CU575

Version Summary

Hardware Change Notes

H/W Version: Rev.G

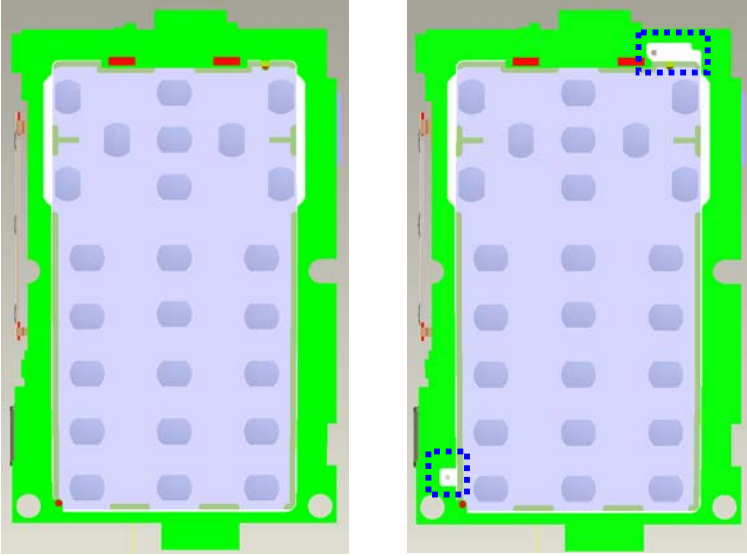
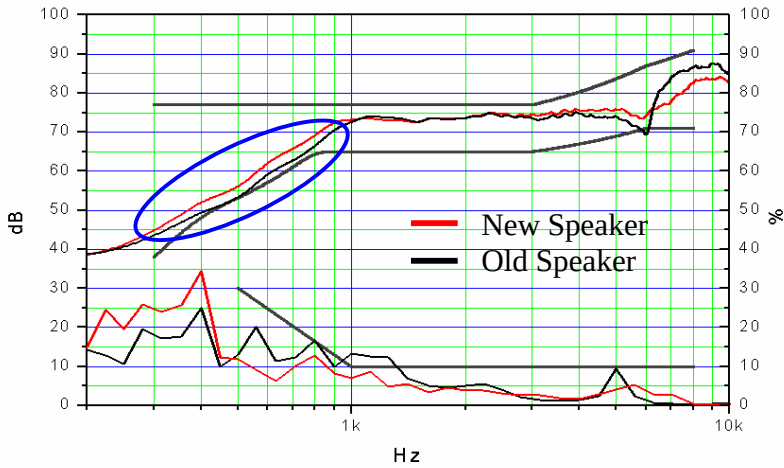
Item	Description
Eliminate the front SD12 of OVP.	In order to improve the performance of a ESD, we used the SD12 to protect a ESD. But in result of ESD test, we decided not to need the SD12.  Before After
Eliminate the TR Switch of a USB.	In order to improve the performance of a USB charging, we eliminate TR switch.  Before After

Change the series inductor position of a speaker line and a motor line.

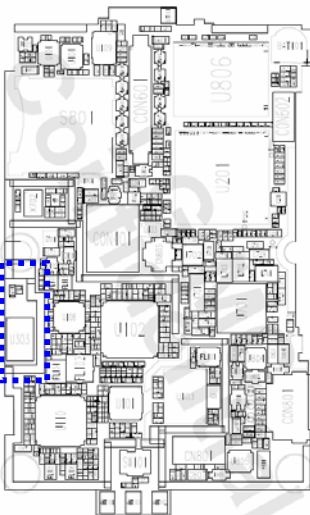
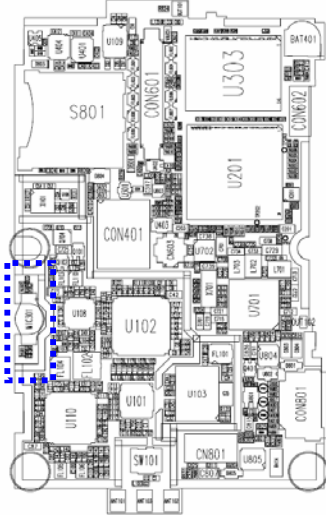
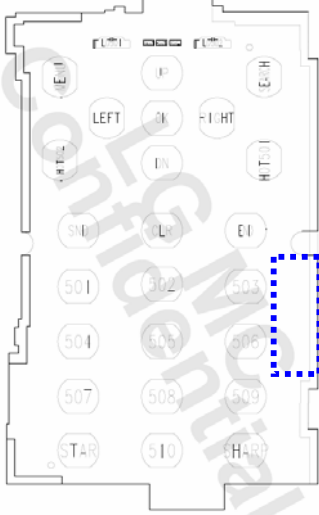
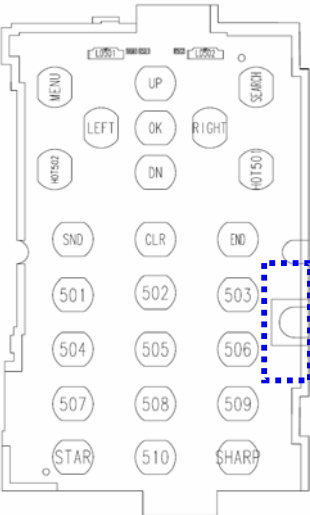
In order to improve the performance of the main antenna, we needed to change the series inductor position of a speaker line and a motor line.

[Change the series inductor position of a speaker line]

[Change the series inductor position of a motor line]
